Project	IEEE 802.16 Broadband Wireless Access Working Group < http://ieee802.org/16 >	
Title	Signaling Acknowledgment Mechanism in MR Network	
Date Submitted	2007-05-2	
Source(s)	<p>Qu Hongyun, Mary Chion, Cancan Huang, Sean Cai Liu Yang, Chen Yuqin ZTE Corporation 712/2, Liantang Pengji Industrial Park, Luohu District, Shenzhen, P.R.China 518004</p> <p>Mo-Han Fong</p> <p>Nortel 3500 Carling Avenue Ottawa, Ontario K2H 8E9</p> <p>Yuefeng Zhou Fujitsu Laboratories of Europe Ltd Hayes Park Central, Hayes End Road, Hayes, Middlesex, UB4 8FE, UK</p>	<p>Voice:+86-755-26773000 exd. 6614 Fax:+86-755-26773000 exd. E-mail: mchion@zteusa.com</p> <p>Voice: +44 (0) 20 8573 4444 FAX: +44 (0) 20 8606 4539 E-mail: Yuefeng.zhou@uk.fujitsu.com</p>
Re:	IEEE 802.16j-07/007r2:“Call for Technical comments and contributions regarding IEEE Project P802.16j”	
Abstract	This document presents sleep mode operations for IEEE 802.16j. The existing IEEE 802.16e messages are reused and new parameters are introduced in order to facilitate the sleep mode management in IEEE 802.16j.

Signaling Acknowledgment Mechanism in MR Network

Figure 20l – Acknowledgement Header

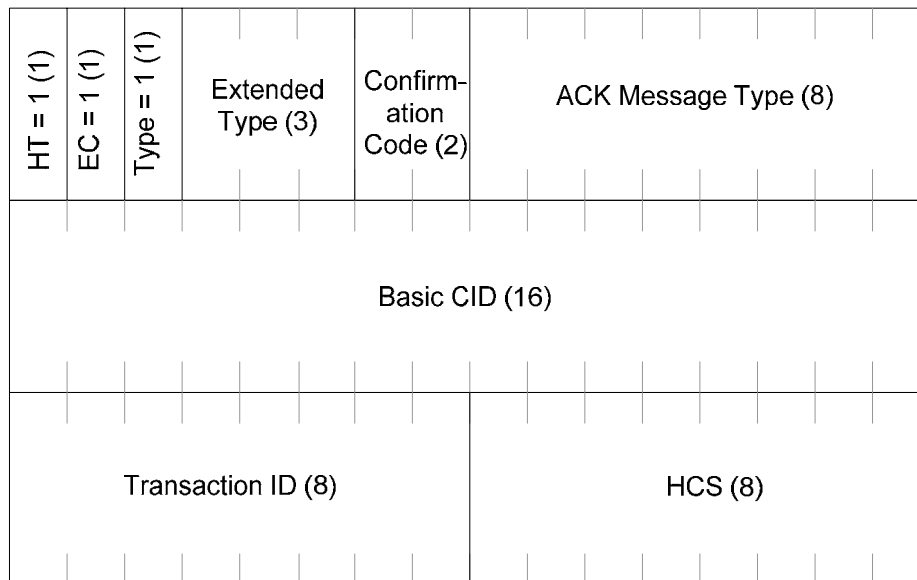
6.3.2.1.2.2.3 Acknowledgment Header (ACK Header)

An Acknowledgment Header is sent by an RS as a response to a MAC management messages received from the MR-BS or its superordinate RS that requires acknowledgment. The RS sends this header to the MR-BS or its superordinate RS as an indication of the message reception. The Acknowledgment Header shall be sent on RS’s basic CID. The Acknowledgment Header is illustrated in Figure 20l. The support of Acknowledgement header is optional for both MR-BS and RS and shall be negotiated during network entry of a RS using REG-REQ and REG-RSP message.

The Acknowledgment header shall have the following properties:

- a. This is a MAC signaling header type II. The length of the header shall always be 6 bytes.
- b. The Type field of this header shall be set to 1.
- c. The Extended Type field of this header shall be set to 0b010
- d. The content of the header is listed in table 7k.
